Comal County Environmental Health

OSSF Inspection Sheet

Permit of Authorization to Construct an On-Site Sewage Facility Permit Valid For One Year From Date Issued

**AEROBIC TREATMENT
DRIP TUBING SYSTEM**

OWNER: DUC PHAM & NHU PHAN		DRAWN BY: EJS III	
STREET ADDRESS: 1460 O.C. TROUT DRIVE			
LEGAL DESC: TRIPLE PEAK RANCH ESTATES	UNIT/SECTION/PHASE: 3	BLOCK: 5	LOT: 6R
PREPARED BY: GREG W. JOHNSON, P.E. F#002585	SCALE: 1"=40'	DATE: 11/29/2023	2nd REVISION: 4/24/2025

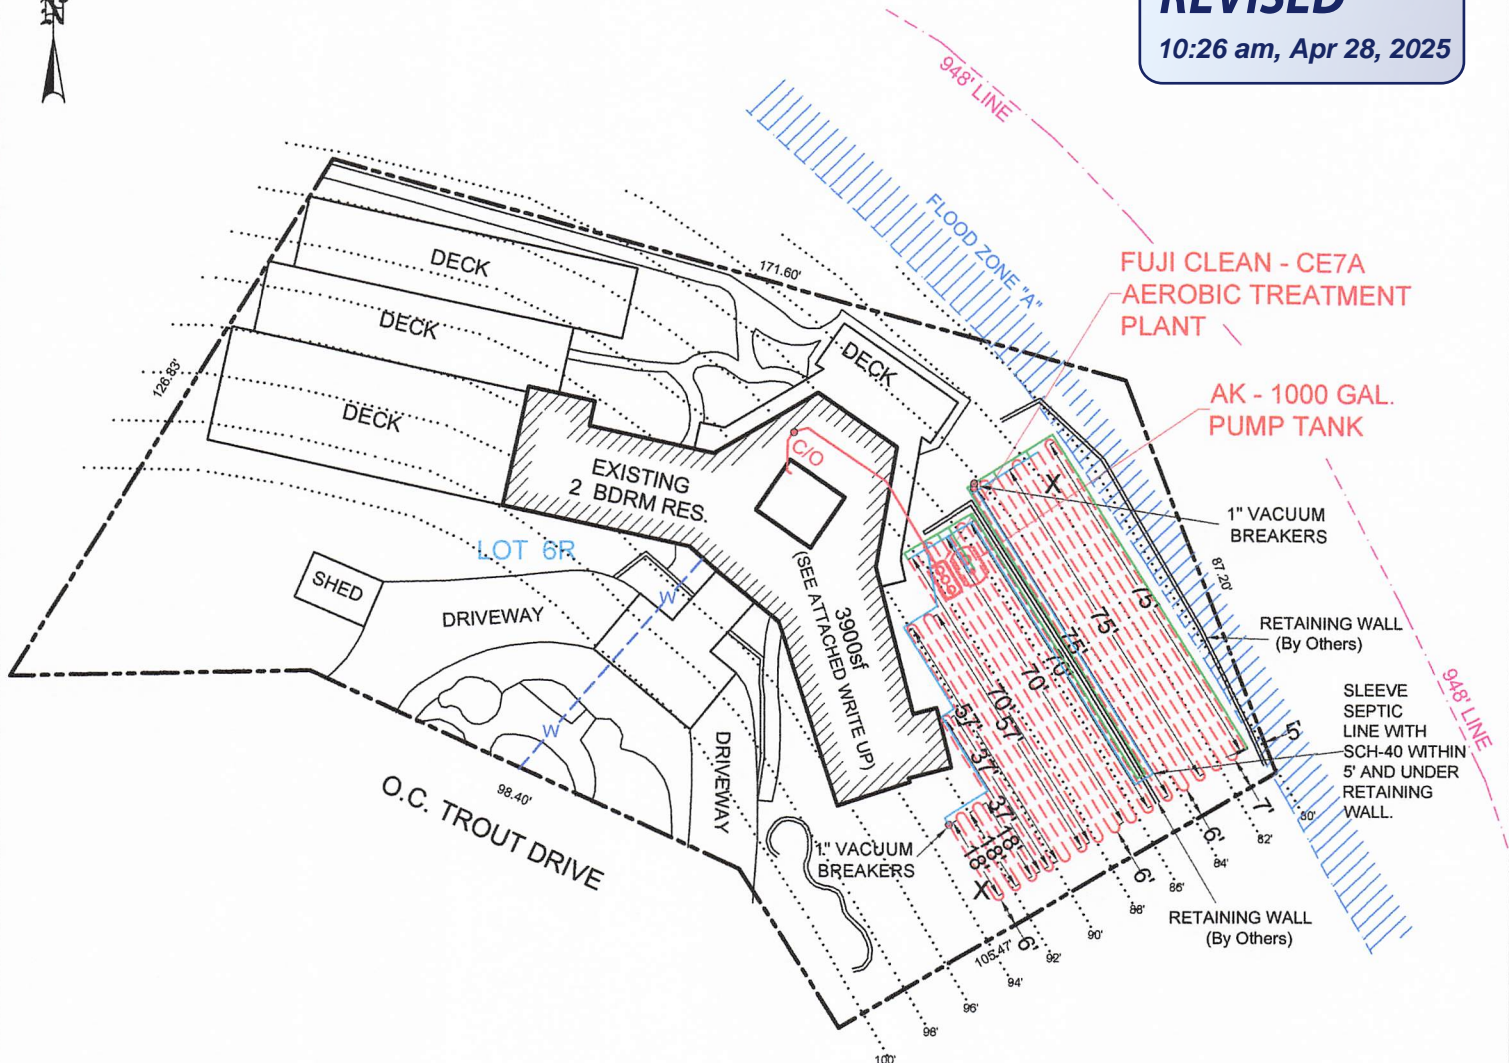
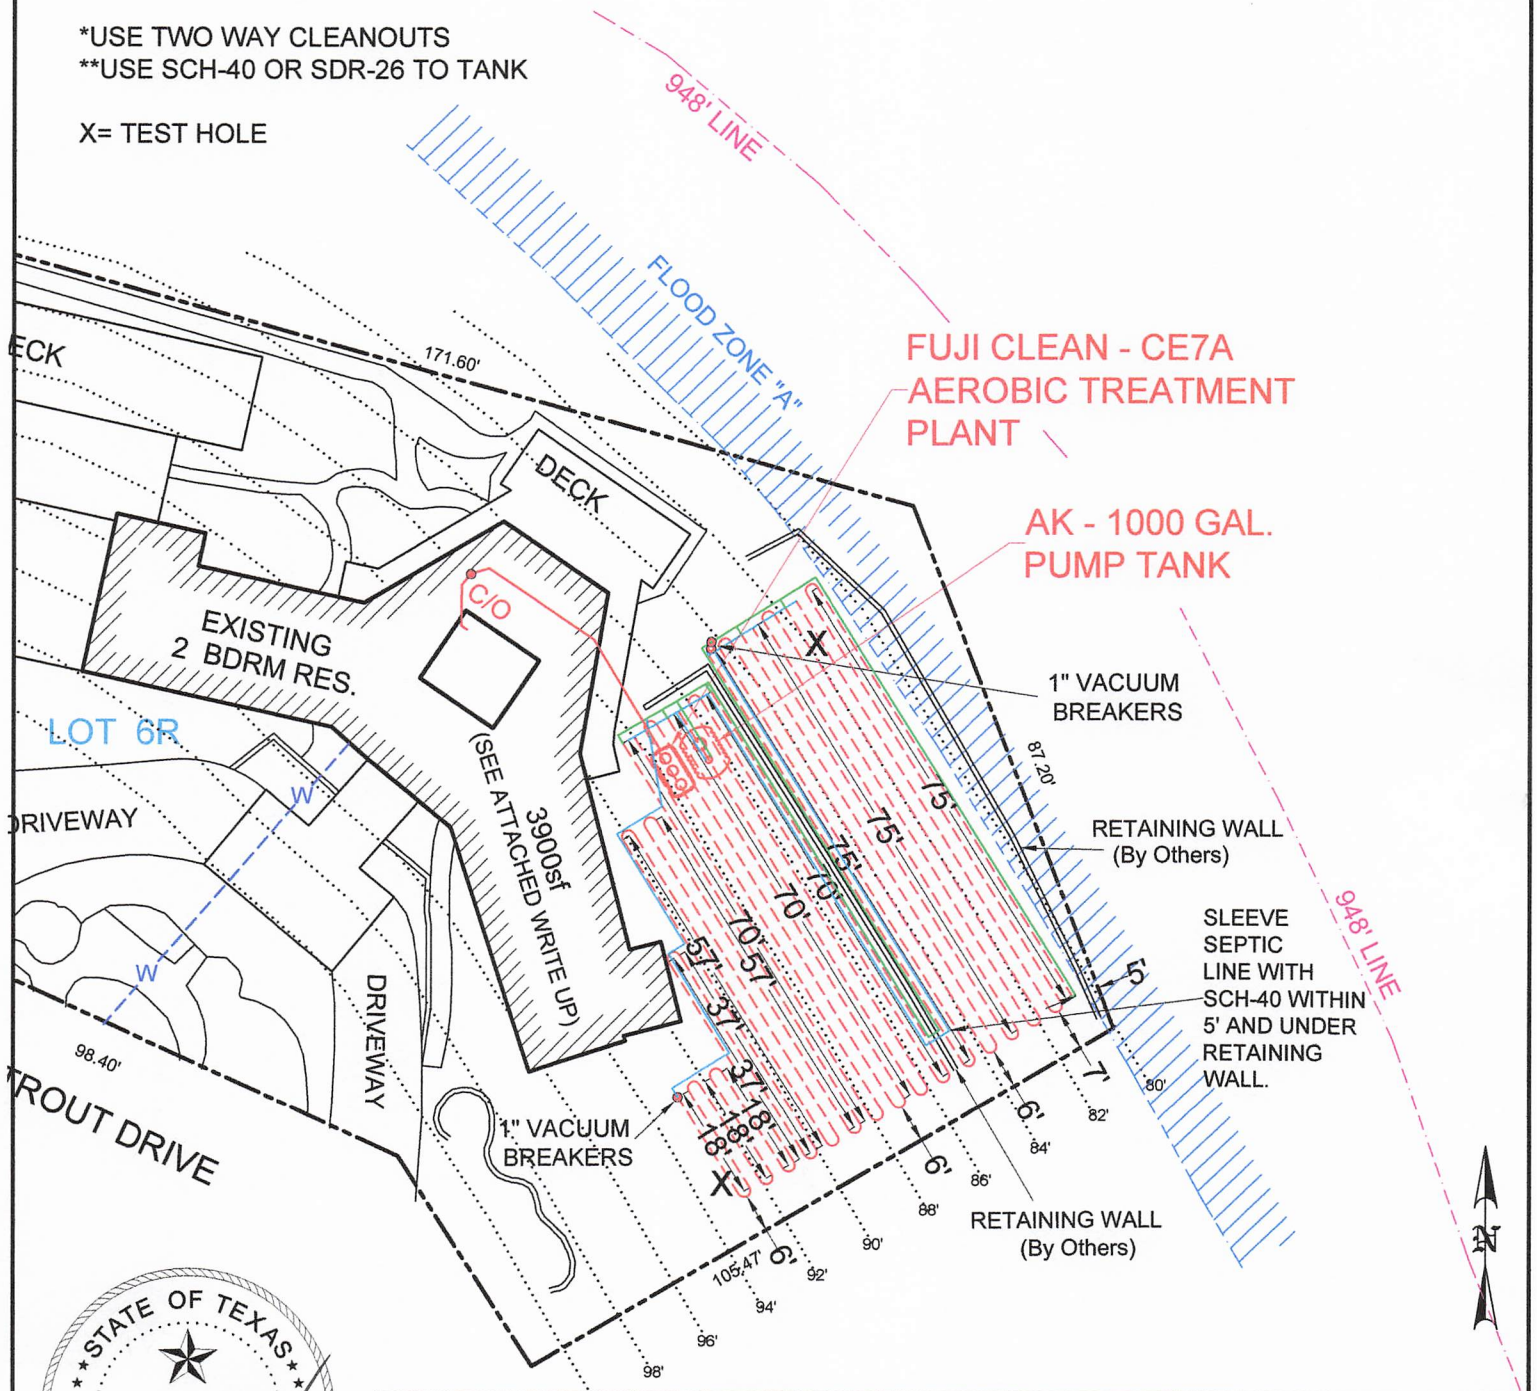
4/23/25 CH: Previous tanks have been backfilled, upper field not installed per design, require design revision with actual layout of tubing and location of tanks before operational, requires re-inspection fee
4/28/25 CH: Installed to design, operational, cover all, requires re-inspection fee

INSTALL 3694sf OF FIELD USING 1847' OF DRIP TUBING BROKEN INTO 2 FIELDS DUE TO SLOPE. RETAINING WALLS BY OTHERS TO REDUCE SLOPE TO LESS THEN 30% SLOPE. THERE SHALL BE NO PARKING, DRIVING OR STORAGE ON THE SEPTIC FIELD AT ANY TIME FOR ANY REASON.

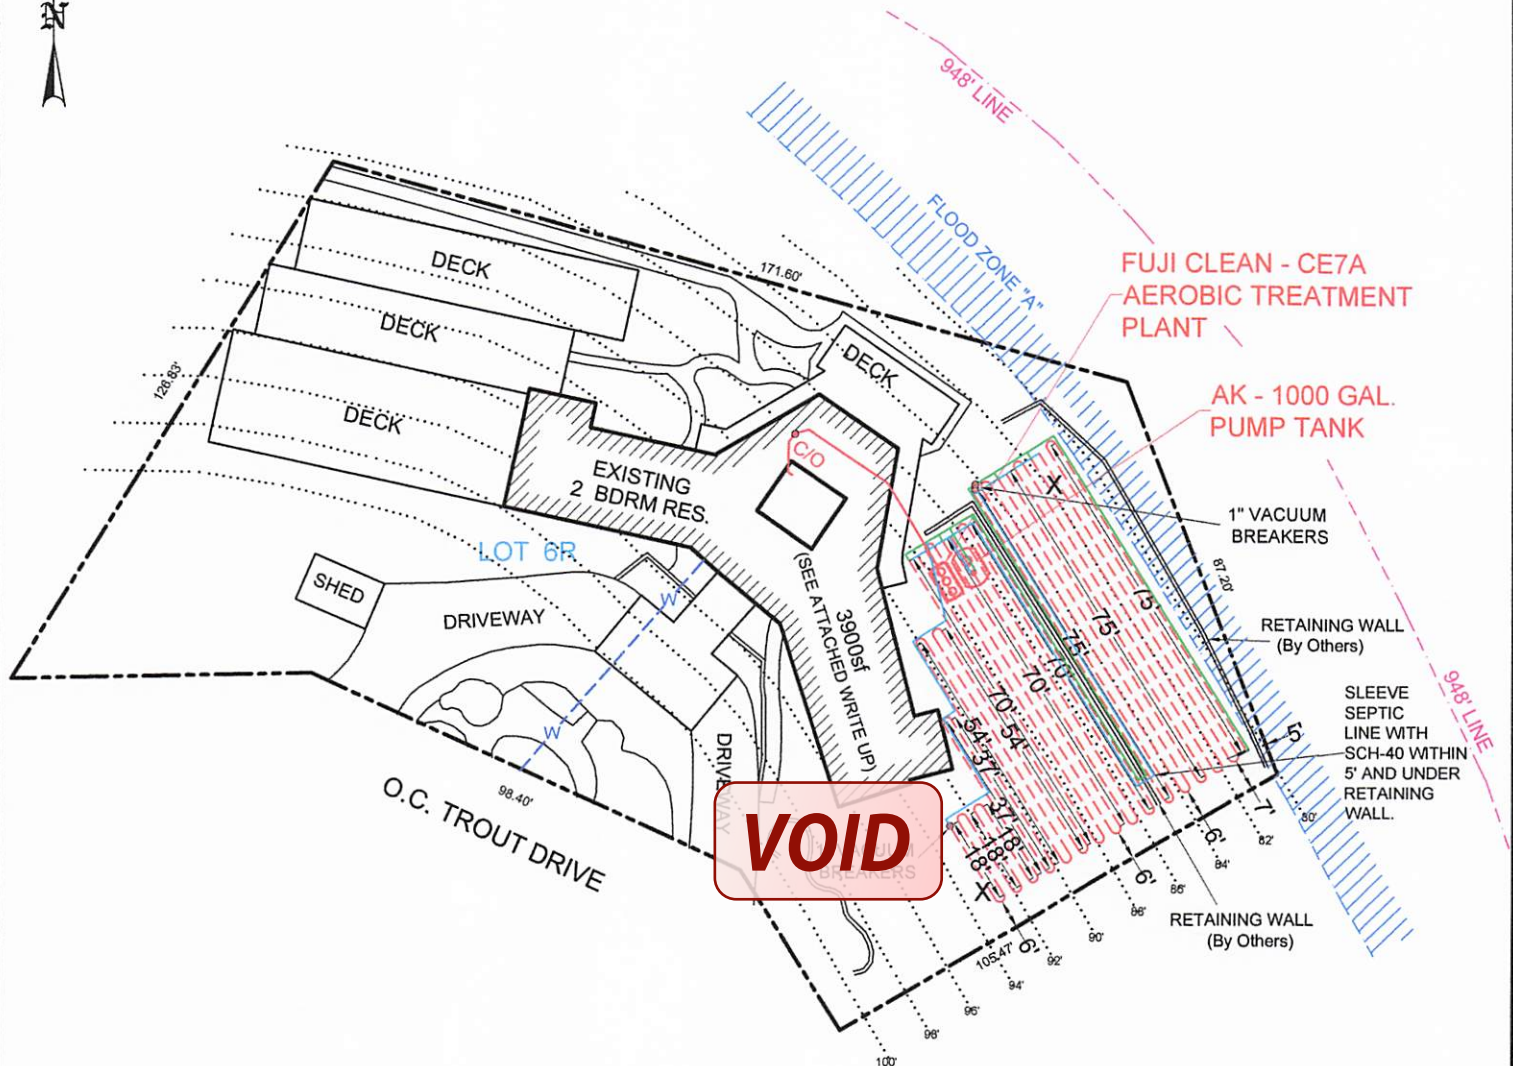
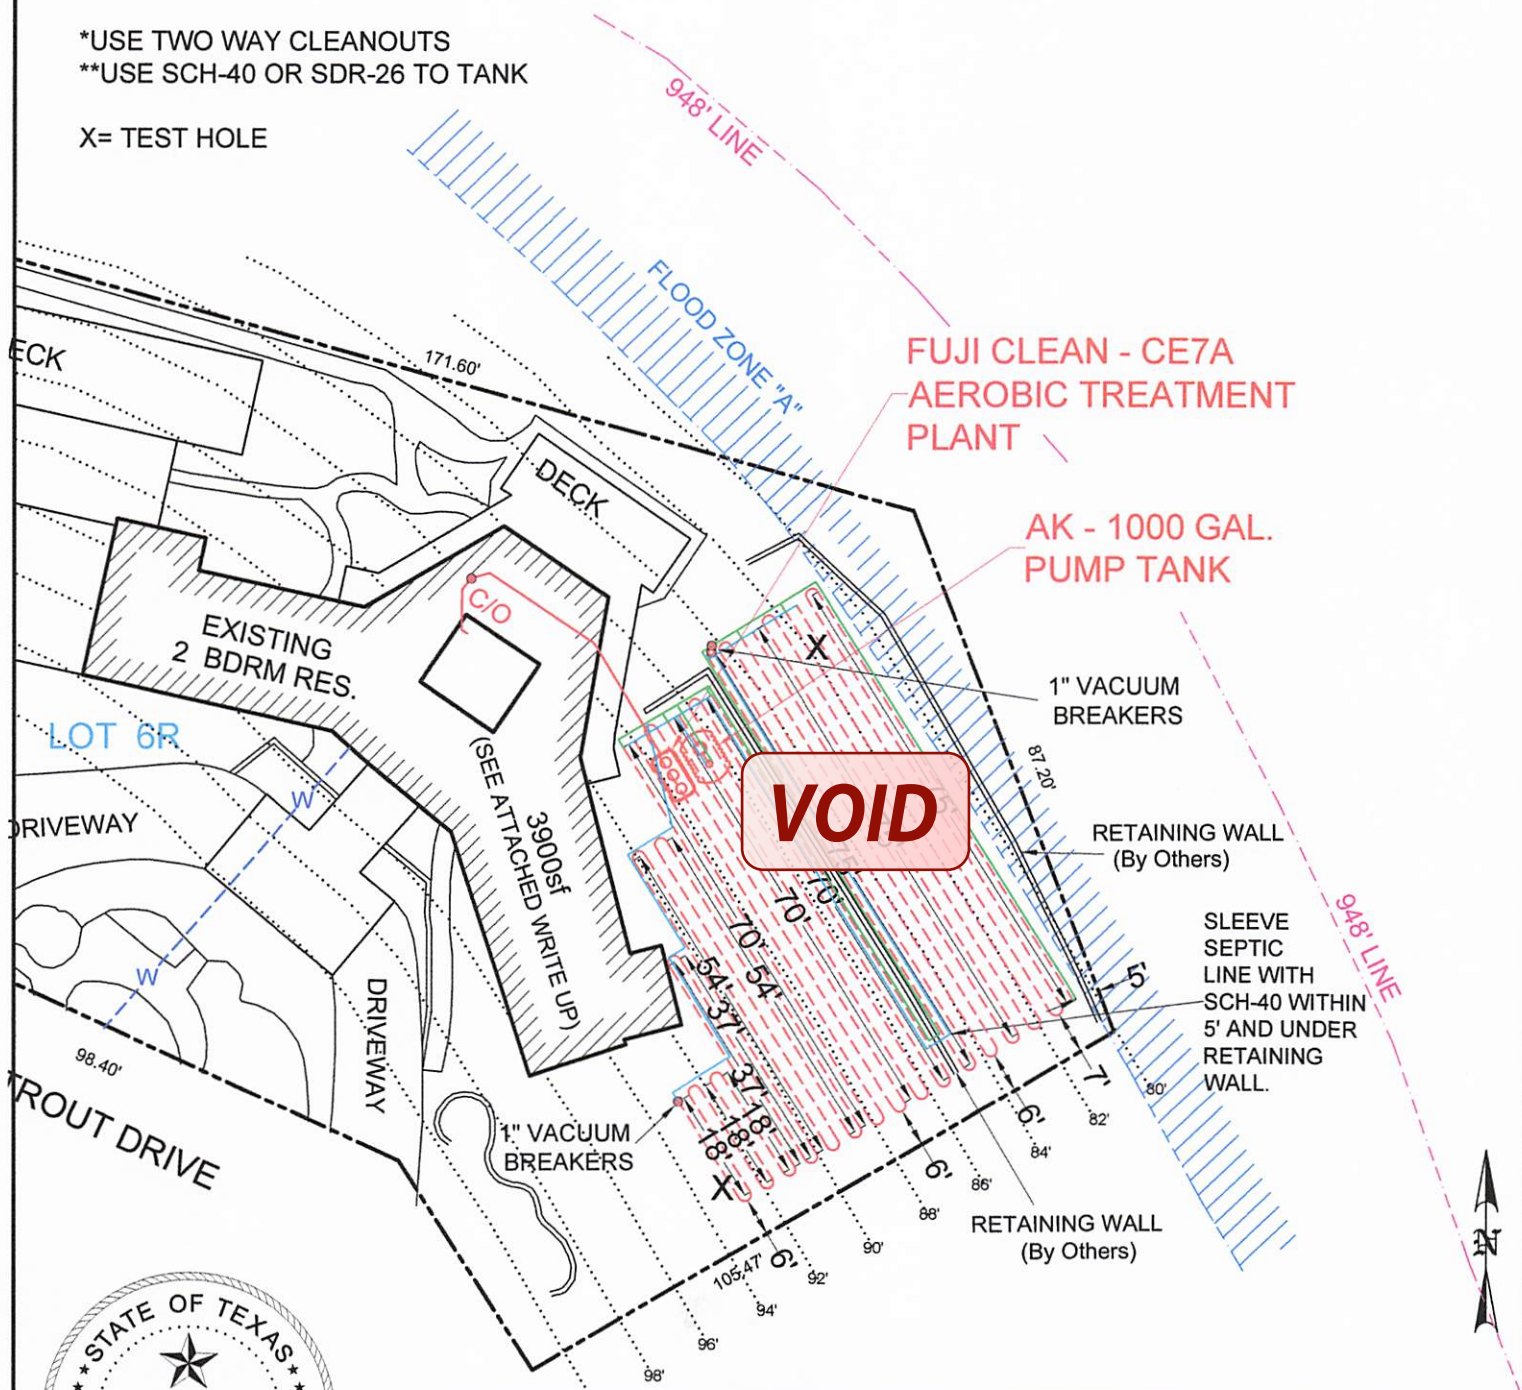
The amount of drip area indicated (3694) does not match the amount of area designed (3670). Please revise as needed and resubmit.

REVISED.
THX,
GREG

OWNER: DUC PHAM & NHU PHAN					DRAWN BY: EJS III	
STREET ADDRESS: 1460 O.C. TROUT DRIVE						
LEGAL DESC: TRIPLE PEAK RANCH ESTATES			UNIT/SECTION/PHASE: 3		BLOCK: 5	LOT: 6R
PREPARED BY: GREG W. JOHNSON, P.E. F#002585		SCALE: 1"=40'	DATE: 11/29/2023		REVISED:

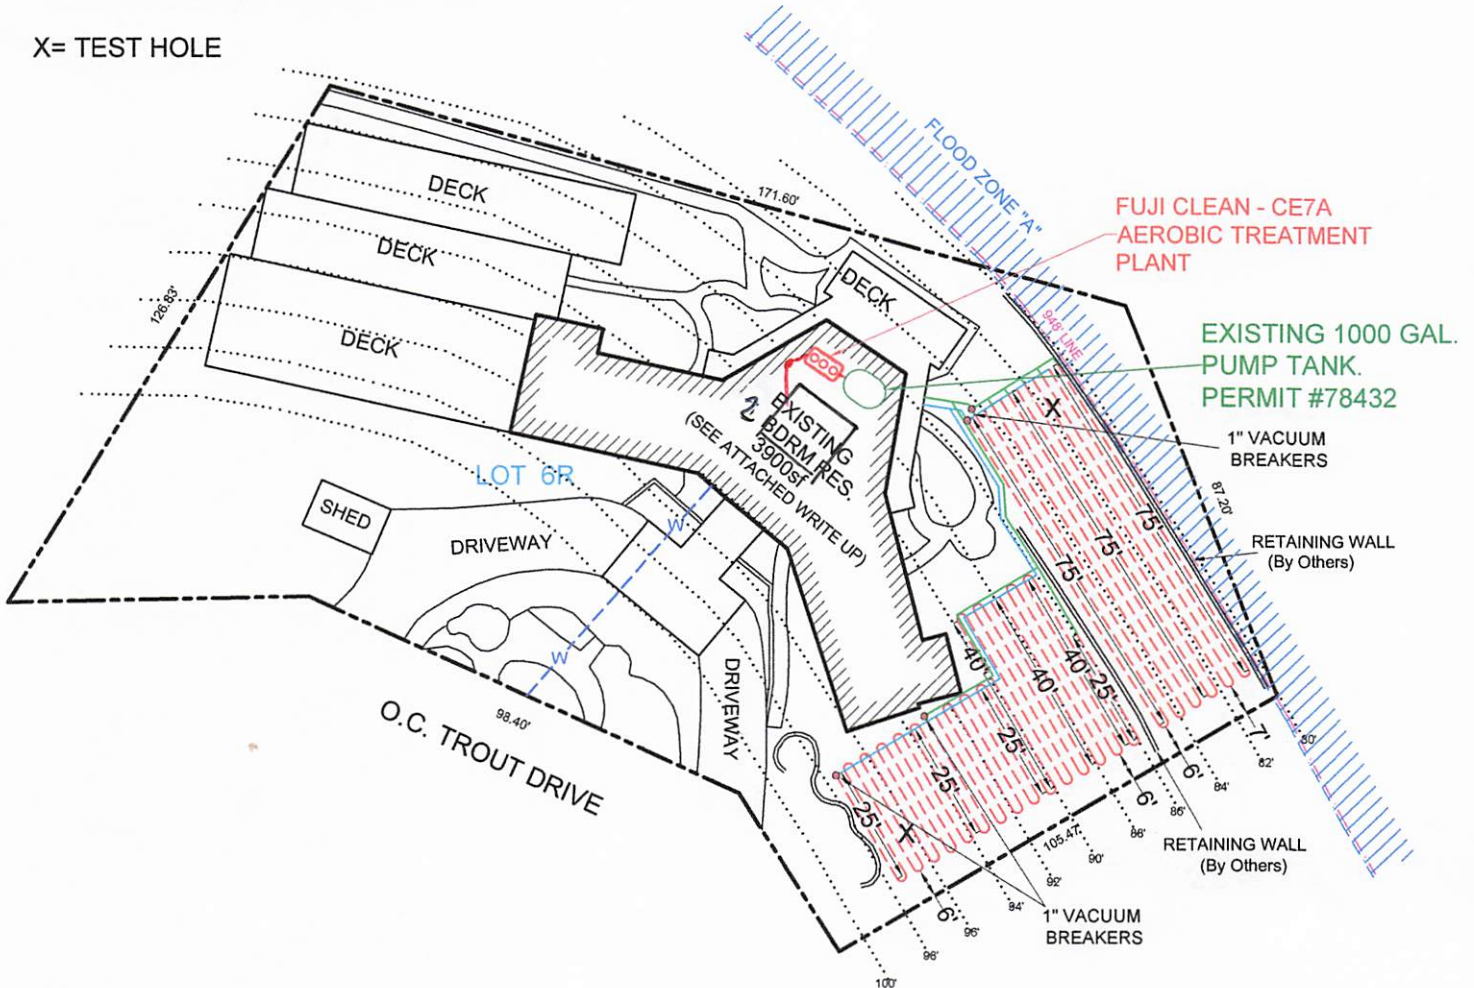
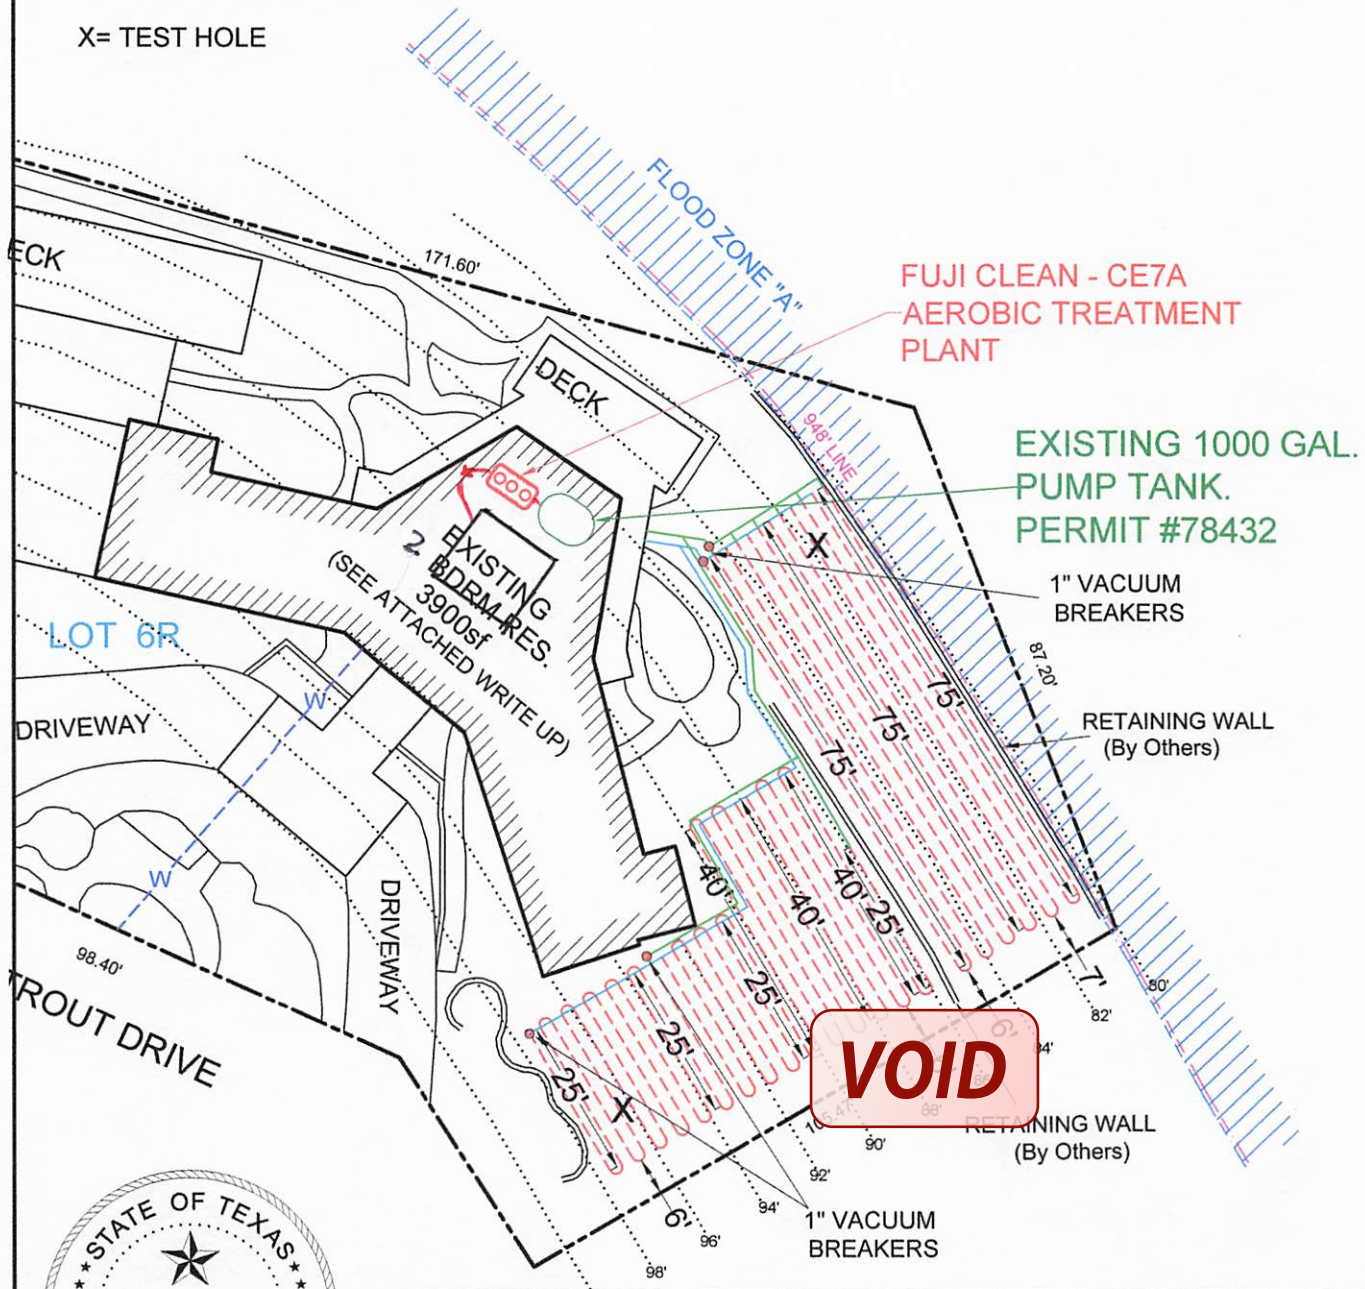
- ✓. Our office will be conducting a site visit on 11-08-2024.
- ✓. Application States 2 Bedroom 3900 sq.ft., planning materials and site plan state 5 bedroom.
- ✓. Is the tank, supply and return line underneath the structure?
- 4. Revise accordingly and resubmit.

REVISED TO SHOW 2 BEDROOM, SIZED FOR 5 BEDROOM DUE TO LIVING AREA.
TANKS AND SUPPLY ARE UNDER THE RESIDENCE AS PREVIOUSLY PERMITTED, BUT
GREATER THAN FIVE FEET FROM STRUCTURE. PIER AND BEAM SUBSTRUCTURE.
THANKS,
GREG
